# SITE PLAN

**Reviewed for Code Compliance**  
 Approved by: Brandon Zipser  
 Permit #: **541-21-000119-STR**  
 Date: **04/15/2021**  
 Reviewed for Lincoln City

SITE PLAN  
6600 LOGAN RD.  
LINCOLN CITY, OREGON  
SCALE: 1" = 20.00'

2400 PLAN  
 6600 LOGAN RD.  
 LINCOLN CITY, OREGON

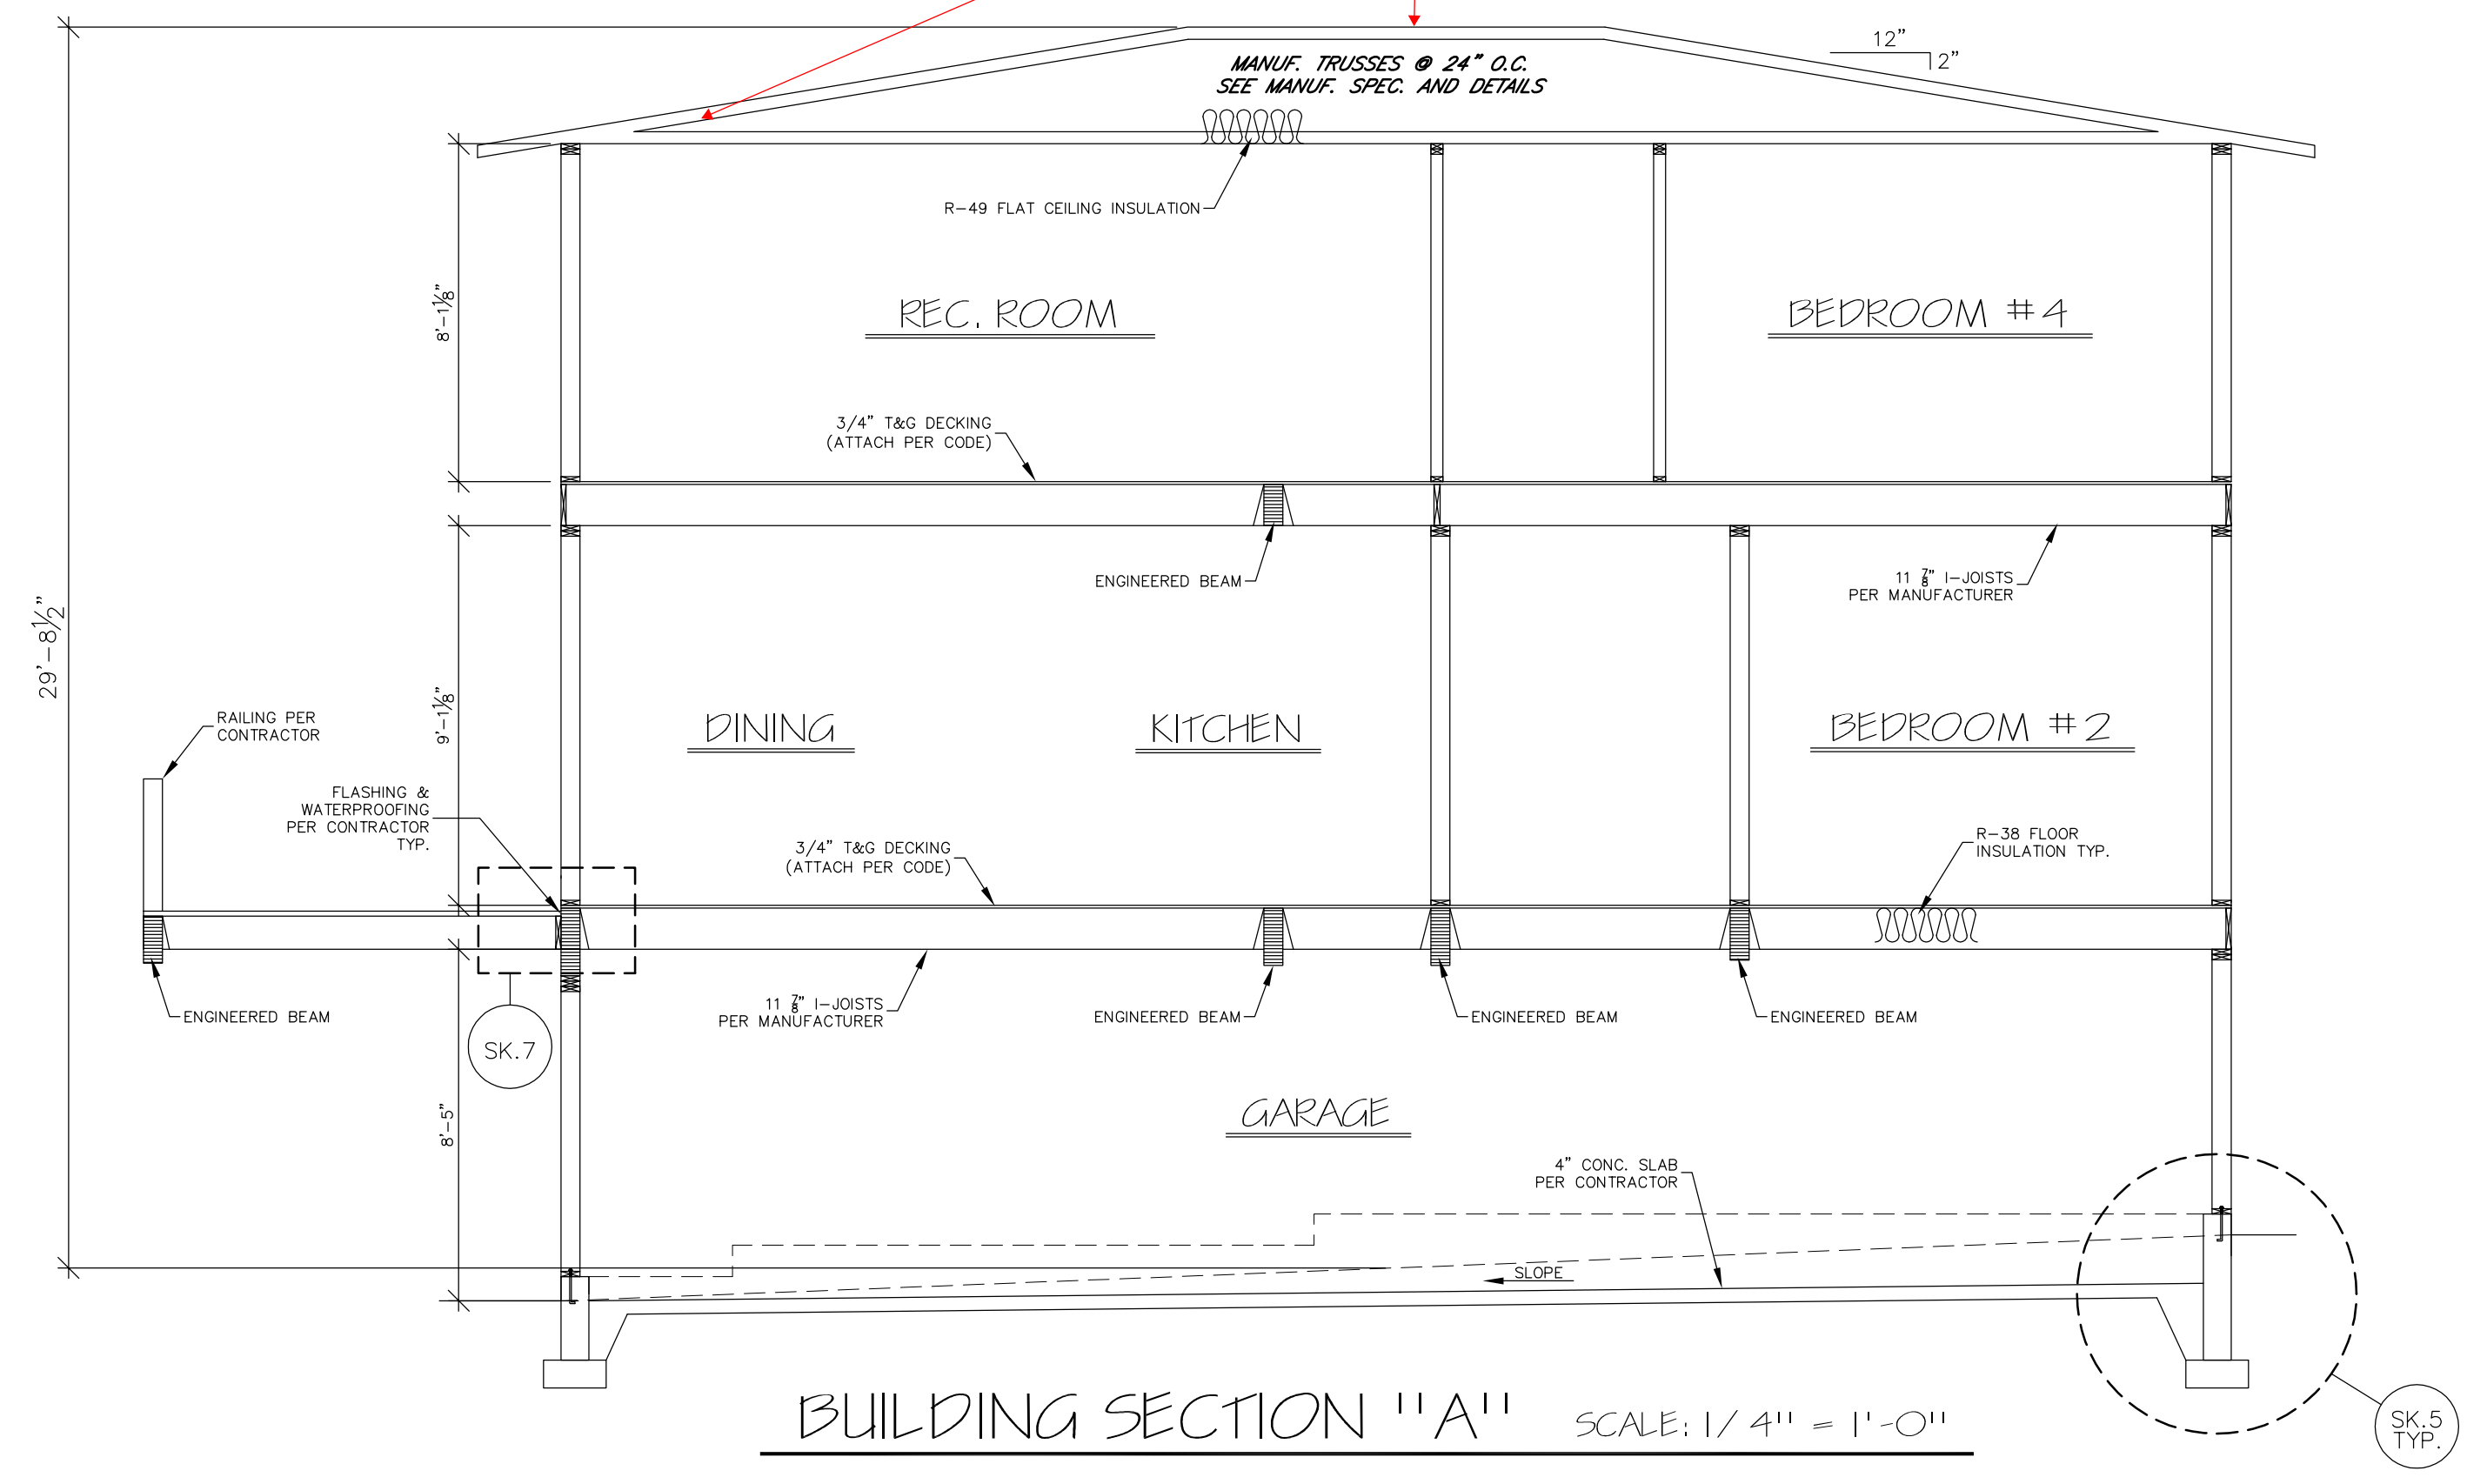
\*\*\*Due to very low profile truss system, required insulation and ventilation is not possible to achieve. Consult inspector, closed cell spray foam may be needed to achieve required R-Value and remove the need for ventilation.

**N1107.4 Solar interconnection pathway.** A square metal junction box not less than 4 inches by 4 inches (102 mm by 102 mm) with a metal box cover shall be provided within 24 inches (610 mm) horizontally or vertically of the main electrical panel. A minimum 3/4-inch rigid metal raceway shall extend from the junction box to a capped roof termination or to an accessible location in the attic with a vertical clearance of not less than 36 inches (914 mm).

Where the raceway terminates in the attic, the termination shall be located not less than 6 inches (152 mm) above the insulation. The end of the raceway shall be marked as "RESERVED FOR SOLAR."

**Exception:** In lieu of 3/4 inch rigid metal raceway, a minimum #10 copper 3-wire MC cable installed from the junction box to the termination point including 6 inches (152 mm) additional wire is permitted.

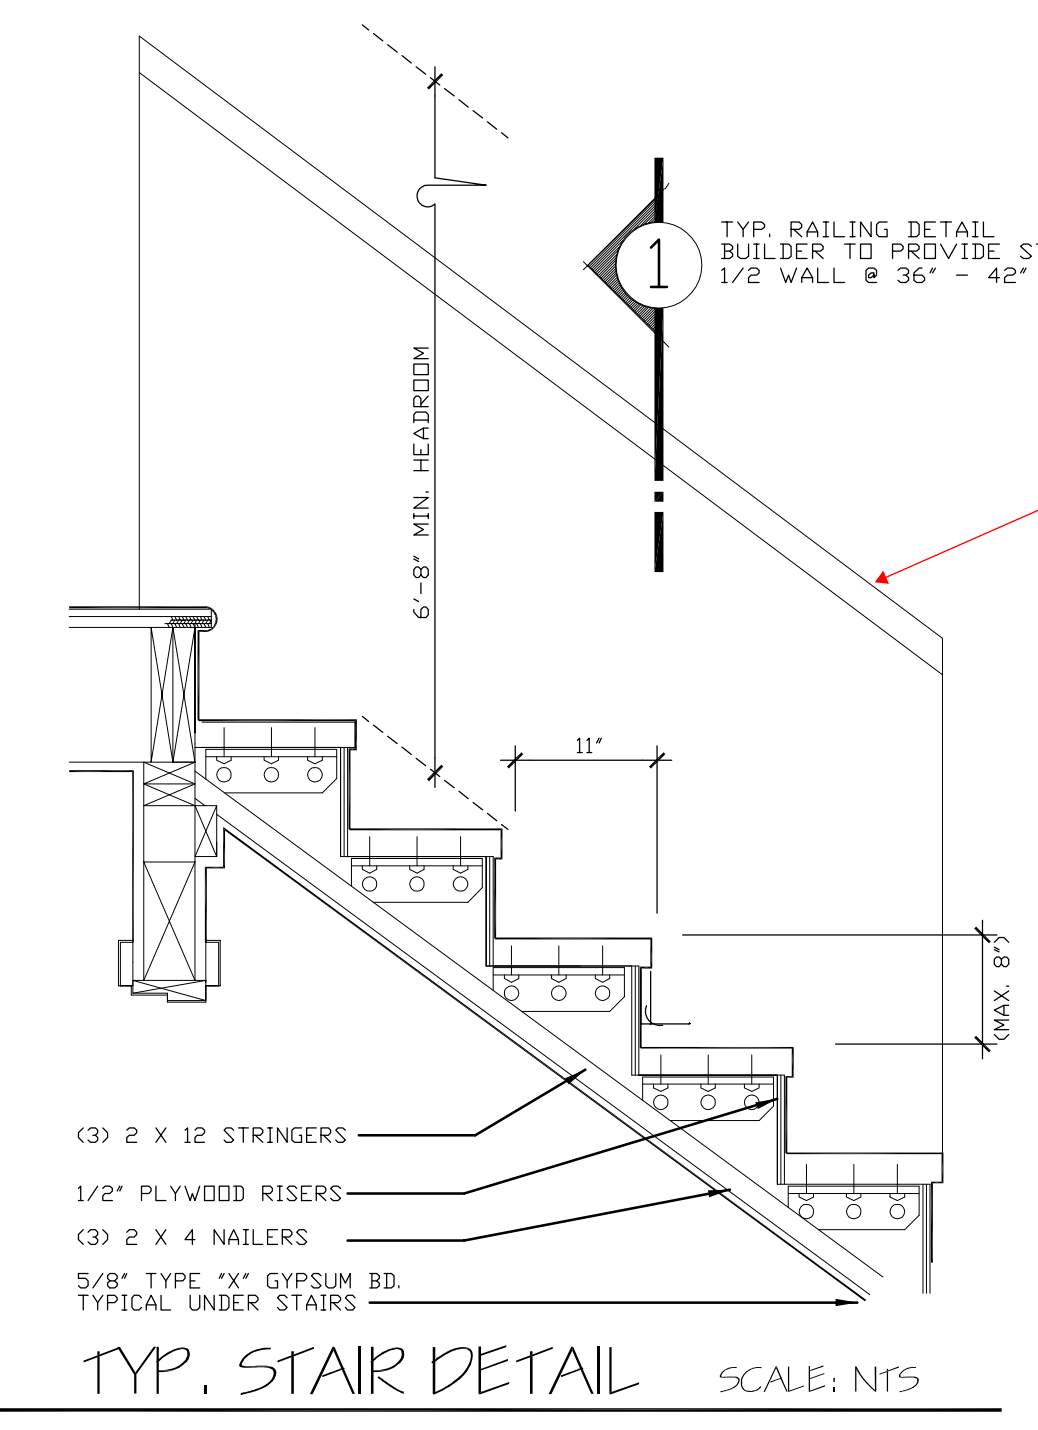
Handrail= 30-38" & must have returns. 1.5" clear from wall. Must be continuous for entire flight.

Guardrails= 36" min at flat surfaces.  
34" min in stair flights.

200# Lateral load design.

**UPPER FLOOR PLAN** SCALE: 1/4\"/>

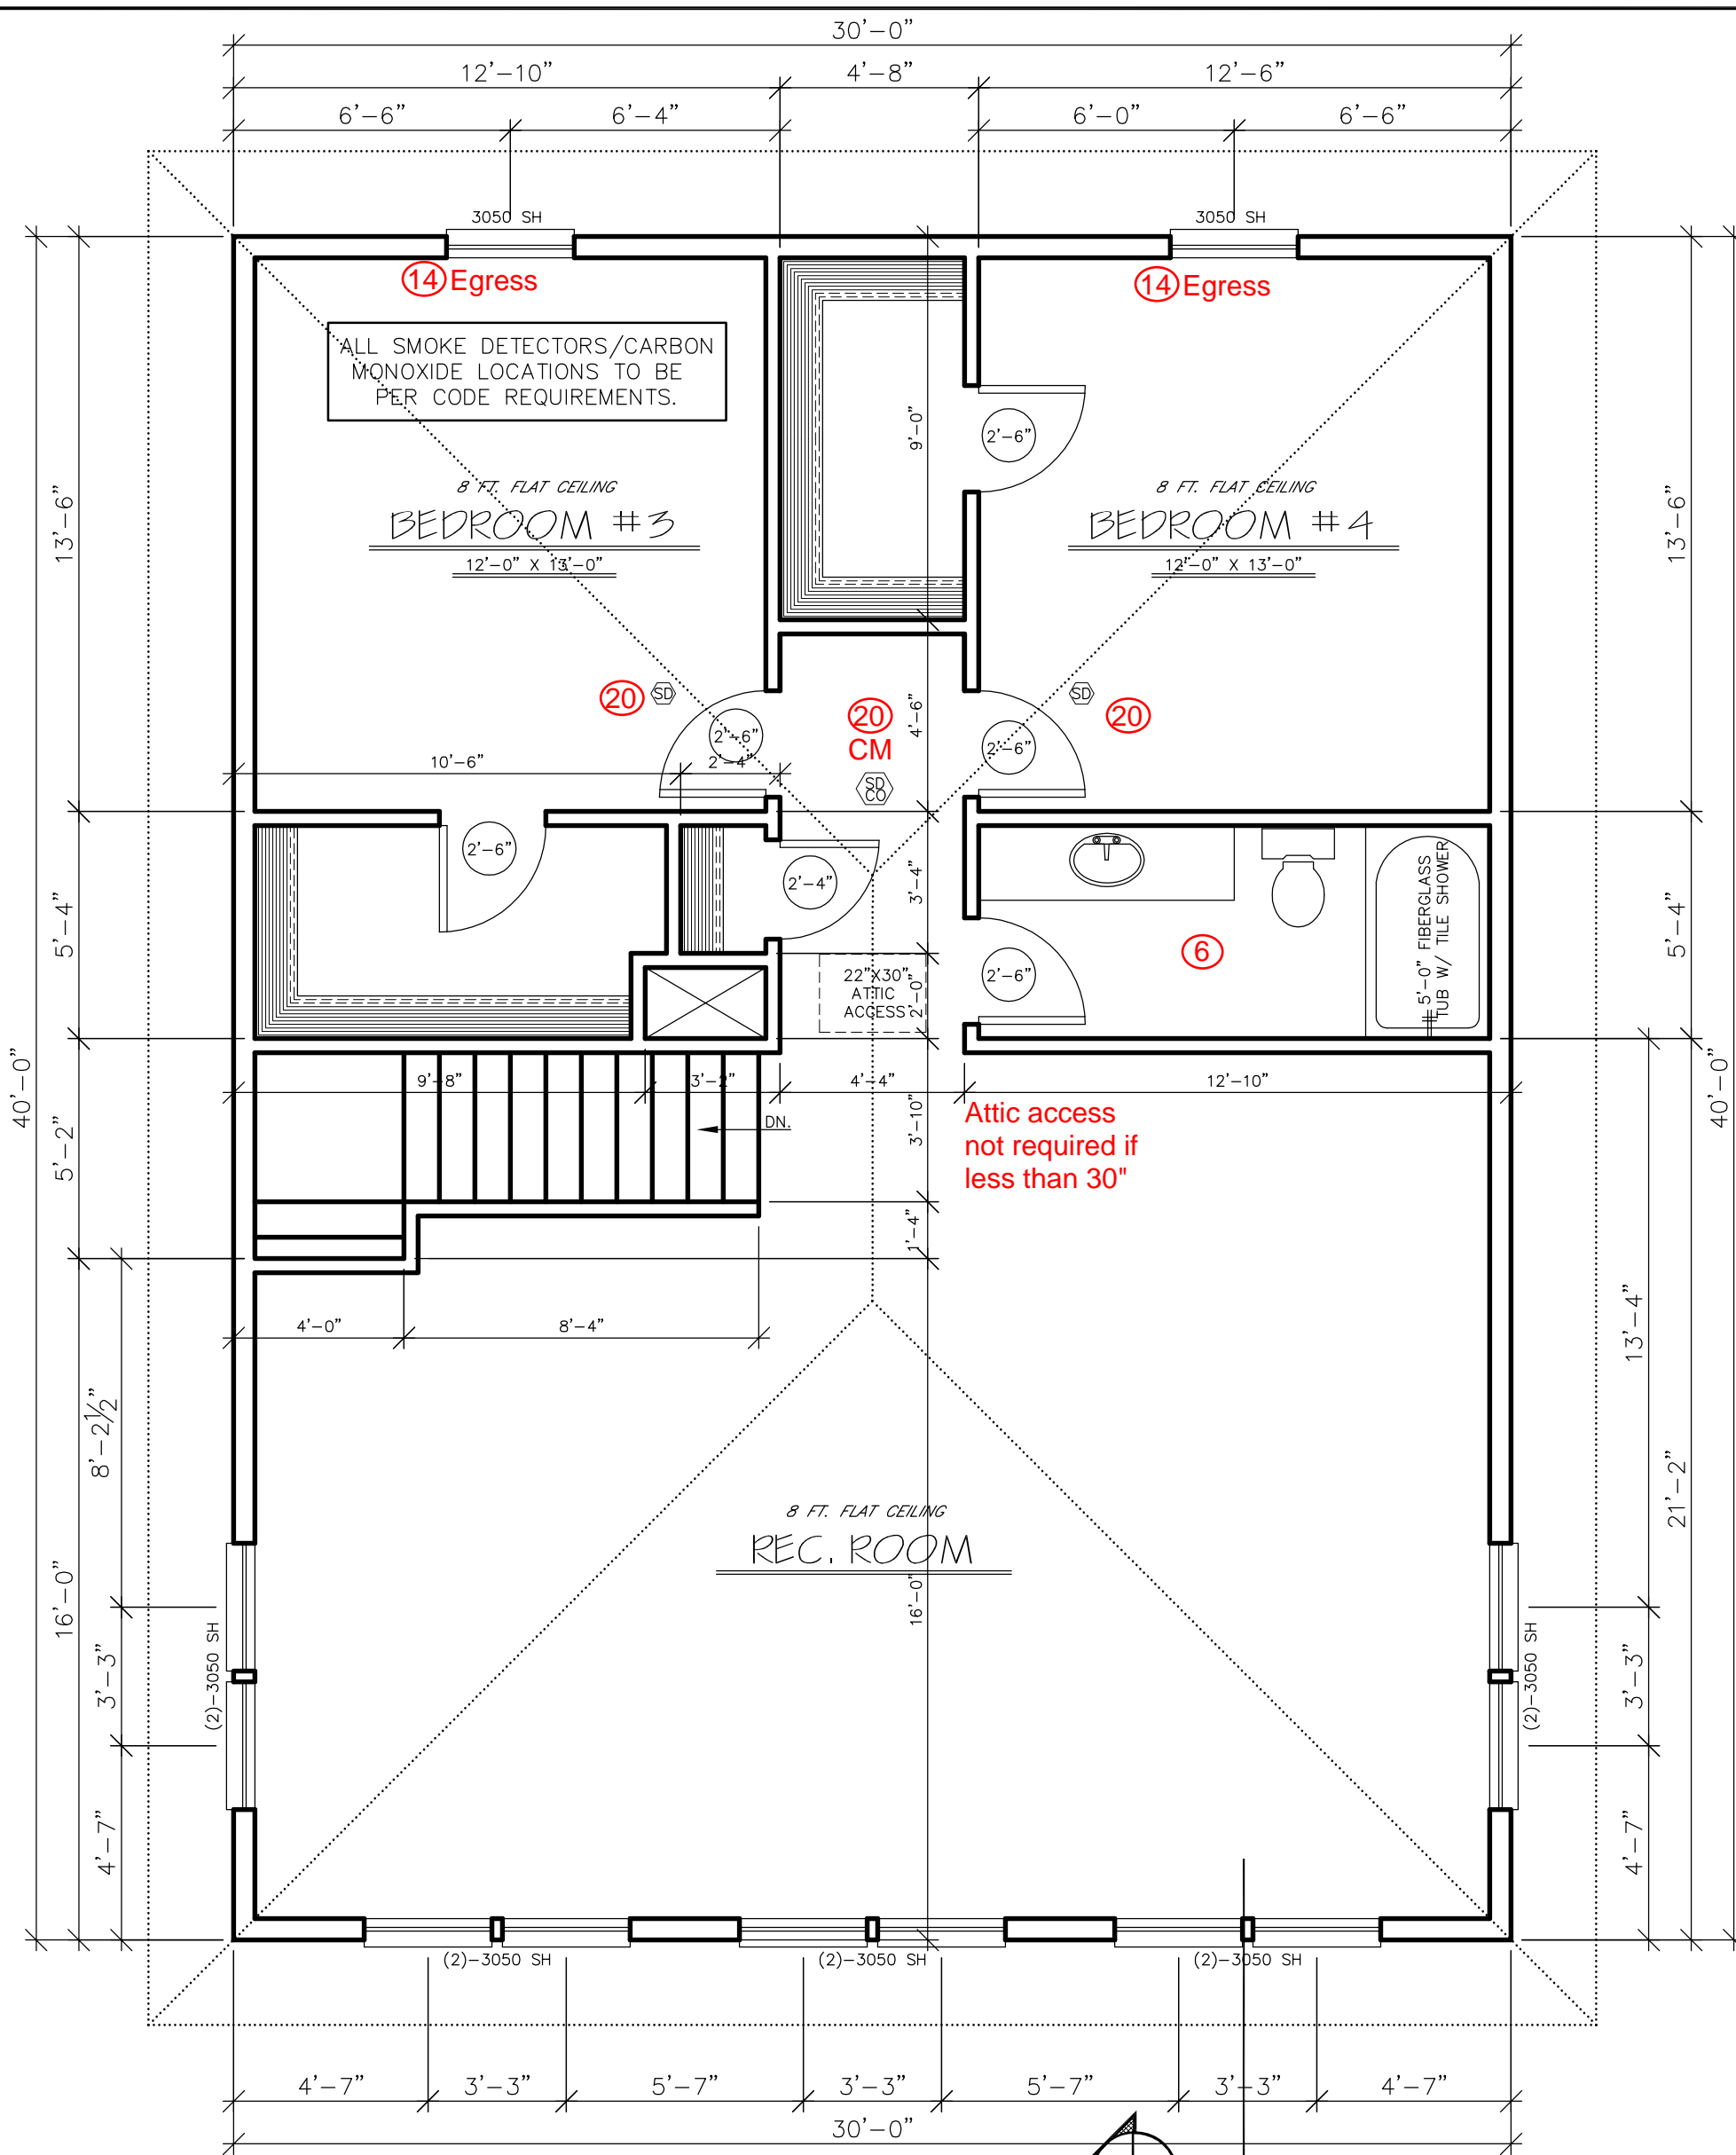
Any opening window with a sill less than 24\"/>
